Minutes of 1 st Meeting of Technical Working Subgroup on Amendment 3 to GTR9	
Title	1 st Meeting of Technical Working Subgroup on Amendment 3 to GTR9
Place	Teams
Status	FINAL
Meeting Date	28 September 2021, 7am-10am EST / 1pm-4pm CEST / 8pm-11pm JST
Prepared By	Benjamin Bünger (Audi), Oliver Zander (BASt)
Purpose of Meeting / Agenda	Discussion on Markup Methods and Test Point Methods for Headform Test Procedure in GTR9 Amendment 3
Issue date	4 November 2021
Next meeting	2 November 2021, 7am-10am EST / 1pm-4pm CEST / 8pm-11pm JST
Invited	Interested Experts from Contracting Parties to the 58 and the 98 Agreements, OEMs and Suppliers

Difference between targeting methods „Measuring Point“ („2D“) and POFC („3D“)

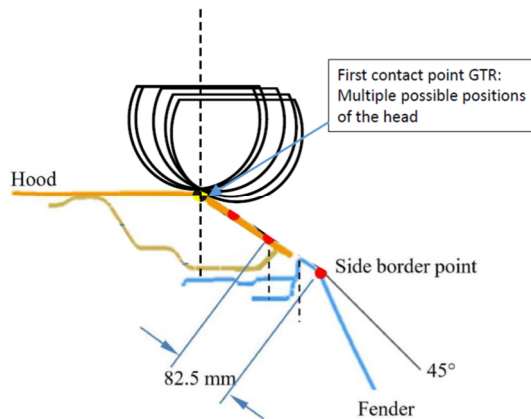
StS explained how a 3D-contact would lead to subjective positioning resulting in different HIC values assigned to the same target, depending on the OEM and/or test lab.

Example: Technical Service choose a test point on an edge

First contact point („3D“) method: multiple positions of head impactor possible, no repeatability or reproducibility given. OEM + TS need to know how a test point has to be tested.

2011 Honda Odyssey

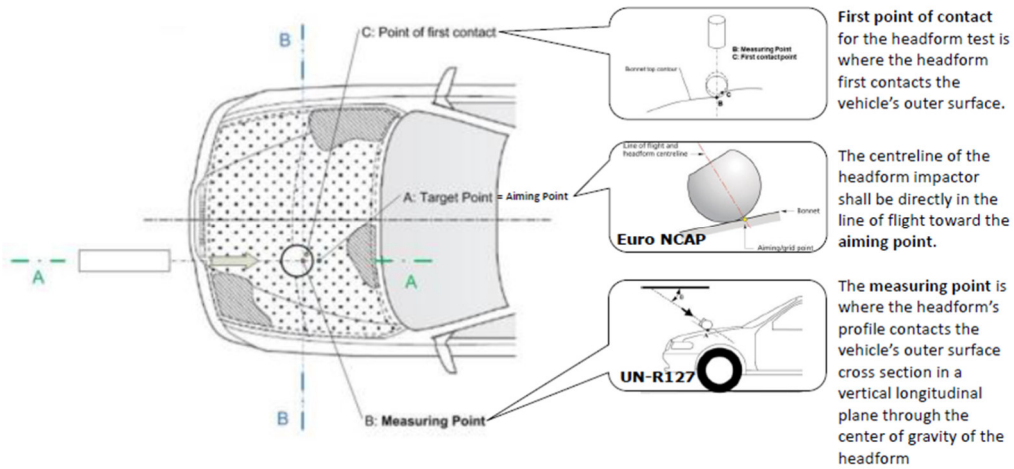
MV recalled TWSG-01-07 (presentation on NHTSA concerns with proposed Amendment 3 to GTR9) and stated NHTSA understood that HIC1,000 in the tested zone must at least lead to a HIC1,000 area 2/3 of the area of the complete bonnet top.

It was replied that this would result in a de-facto HIC1,700 assignment of the entire offset zones which would not be true or accurate. Besides, this wouldn't reflect but exceed the GTR9 (minimum) requirement of HIC1,000 over 2/3 of the test area. Furthermore, it would imply that at least 2/3 of the complete bonnet top area with a requirement of HIC1,000 must be testable (i.e. be located within the test area) which is not written in GTR9. In addition, the shown example (Honda Odyssey) would only allow a maximum of 2% of the testable area to be assigned to the HIC 1,700 zone. It was questionable whether this could be the intention of the introduction of the 1/3-2/3 rule.

MV indicated that a proposal considering only the testable part of the bonnet top could be reasonable and that she may prepare such a proposal for the next meeting.

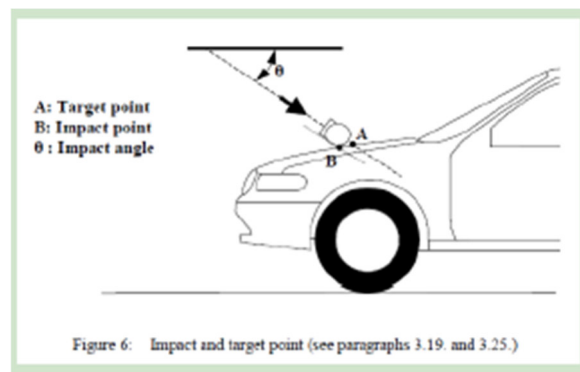
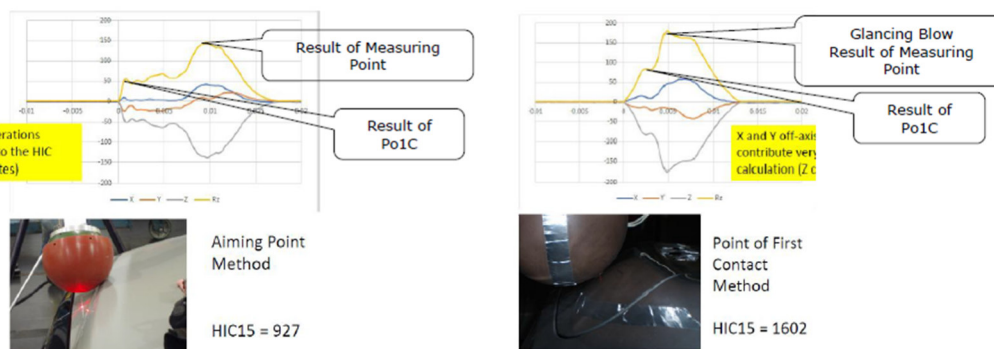
OZ explained the different concepts behind the target/aiming point, the point of first contact and the measuring point (TWSG-01-06).

3.19 of GTR No.9 described a 2D derived "impact point" and it related to the velocity vector without addressing lateral deviation.

If there was a misunderstanding in the impactor alignment, tests with the impactor virtually outside the test zone would result. Target and measuring points were stated mainly contributing to the test result, with data supporting the statement.
